SUNDRY NOTICES AND REPORTS ON WELLS

Atlantic  
Fruitland 24 Com #1

Propose to change casing program from a cased hole completion to a open hole completion. Revised Drilling Plan attached.

# ***DRILLING PLAN***

**Exhibit #1A**  
**BOP Stack Arrangement**  
**Open-Hole Completion Rig Operations**

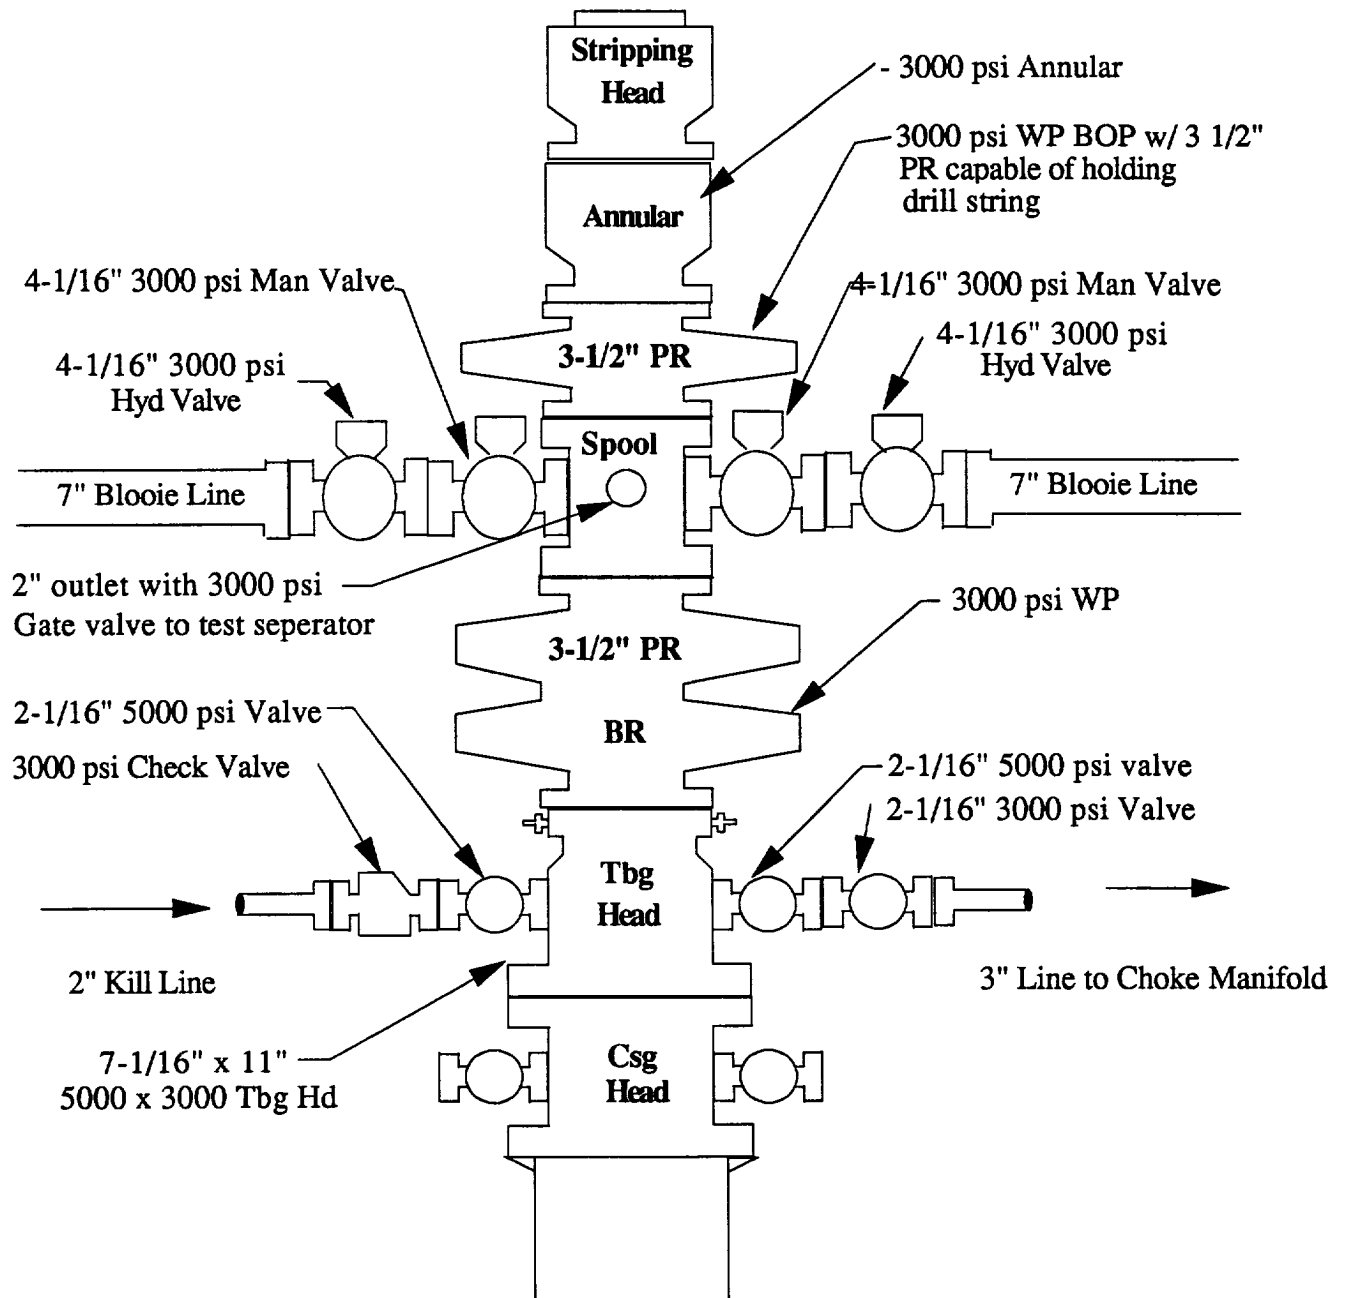
D. The well is planned to be completed Open-Hole style. The Fruitland will be drilled out from under 7" Casing using a Completion Rig and utilizing water as the drill fluid. After reaching TD, air will be added to the water to induce gas/water flow from the coal. Should wellbore stability be a problem, a 5-1/2" liner will be run to TD with 100' overlap across the 7" casing. The liner will not be cemented but will be perforated.

The maximum anticipated Fruitland pore pressure is 1500 psi. The Fruitland will be drilled out under balanced approximately 300 psi. A completion rig will be utilized for this operation using the BOP equipment specified in Exhibit #1A & #2A. There are no other abnormal pressures, temperatures or potential hazards in the area.

<u>Interval</u>	<u>Pressure Control Equipment</u>
500'-3103'	11", 3000 psi double ram preventer with Rotating Head (Exhibit 1 &2).
3103'-3395'	2 - 7 1/16" double ram preventers with Stripping Head (Exhibit 1A & 2A).
